DEVELOPMENT REVIEW BOARD

Planning Dept. - Major Case Comments

Project Number: PR-2021-005597

Project Name: The University of Albuquerque Urban Center

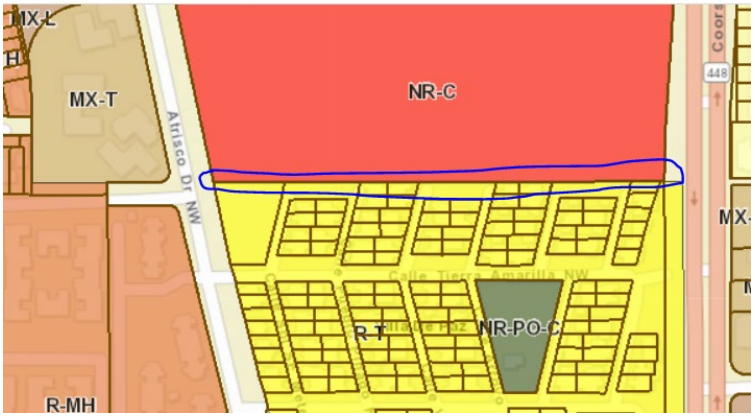
- **Updated 3/17/22**: The IDO requires a landscaped edge buffer of 15 feet when non-residential development is next to low density residential development. Lots along your southern boundary will need to provide a 15-foot landscaped buffer to the R-T zoned residential project to the south. Please make sure the edge buffer is accommodated in the southern lot sizes. See IDO 5-6(E)2.
